Staff Report City of Richmond, Virginia

Commission of Architectural Review

3. COA-123205-2023	Final Review Meeting Date: 3/28/2023
Applicant/Petitioner	Joshua Shaheen
Project Description	Installation of a mural on the side of a single-family detached dwelling.
Project Location	519/515/513/511/509/ • • • • • • • • • • • • • • • • • • •
Address: 313 N Monroe St	589 507 505 503 501 481 402 400 400 400 400 400 400 400 400 400
Historic District: Jackson Ward	310 315 487 315 487 316 316 316 316 316 316 316 316 316 316
High-Level Details:	• 508 407 405 401 405 502 504 422 418 500 401 512 51
Applicant requests approval to install a mural on a non-painted side elevation of a masonry, Italianate, semi-attached dwelling circa 1900.	501 8road Street.
The mural will face the alley.	22 32 318
This is a retroactive approval request, as the mural was painted without review and approval by the Commission. This review is the result of a notice of violation.	423 419 411 401 412 412 413 414 415 417 404 417 404 418 419 419 410 410 411 411 412 412 412 413 414 415 416 417 417 418 418 418 418 418 418 418 418

Figure 1. façade photo

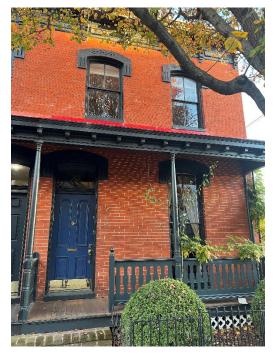
Staff recommends approval of the abatement method outlined in the estimate provided by the applicant.
Maintenance and Repair, Masonry,	Unpainted masonry should remain unpainted.	The mural installed at 313 N Monroe Street has been painted on unpainted masonry. This is in violation of the <i>Guidelines</i> , as stated on pg. 89
pg. 89		Painting historic masonry can exacerbate brick spalling. Brick spalling is caused when moisture from the ground or air is absorbed into the brick and is unable to escape. The moisture inside the brick freezes in the winter, and thaws in the summer. This repeated freeze and thaw cycle eventually leads to the face of the affected brick popping off, exposing the interior of the brick. Without the hard, kiln-fired brick face, the softer interior of the brick is exposed making the brick more susceptible to moisture and further damage. Unlike modern construction that has a brick
